M14/D10
TWO PLANS

DRAINAGE PLAN

GRADING AND DRAINAGE PLAN
JOHN SEXTON & CO.

GRADING AND DRAINAGE PLAN
JOHN SEXTON & CO.

SHEET 1 OF 2

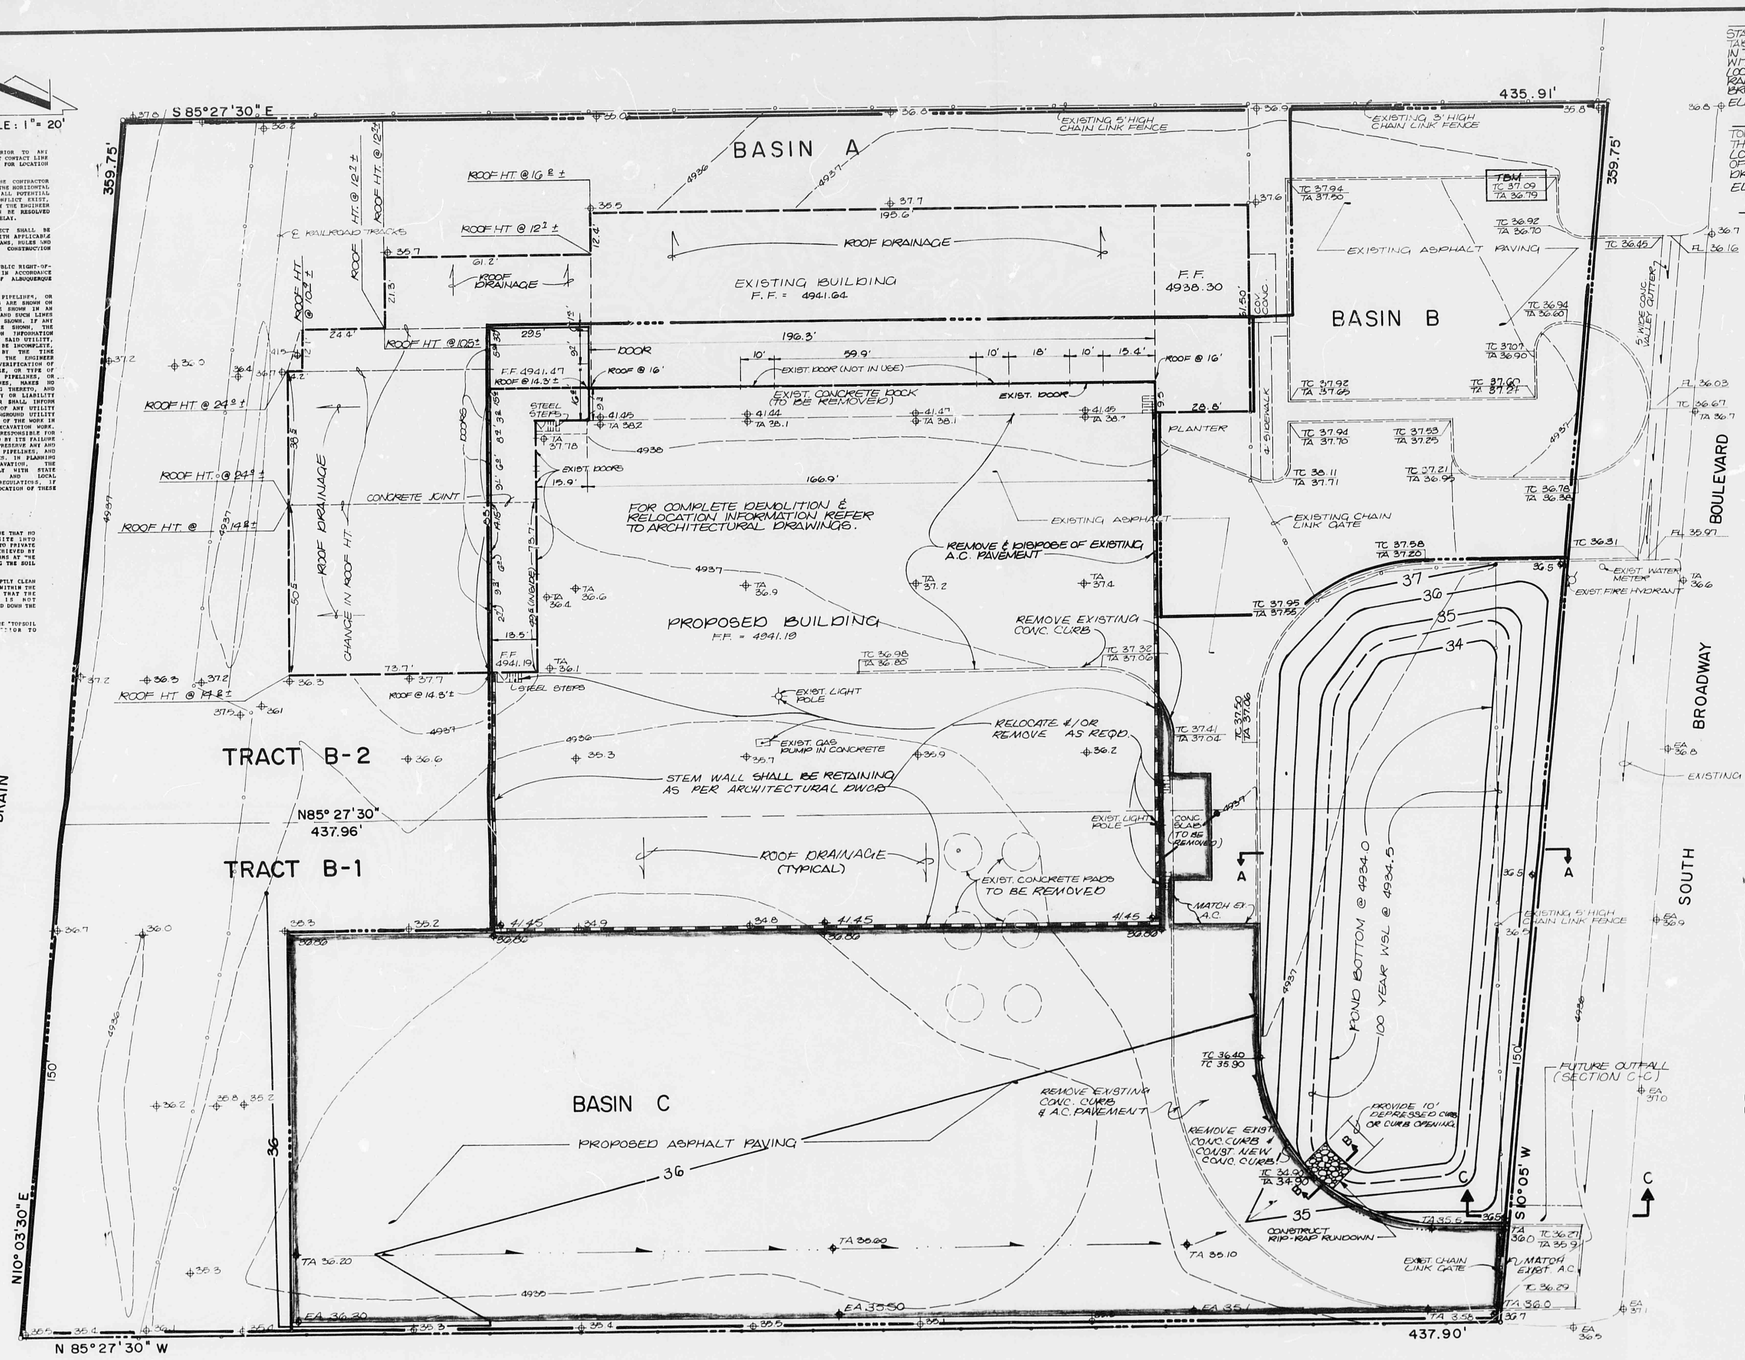
1. RESPONSE TO COMMENTS DATED 6-6-86
   a. Future Outfall as shown hereon
   b. No off-site public waters enter proposed retention pond.
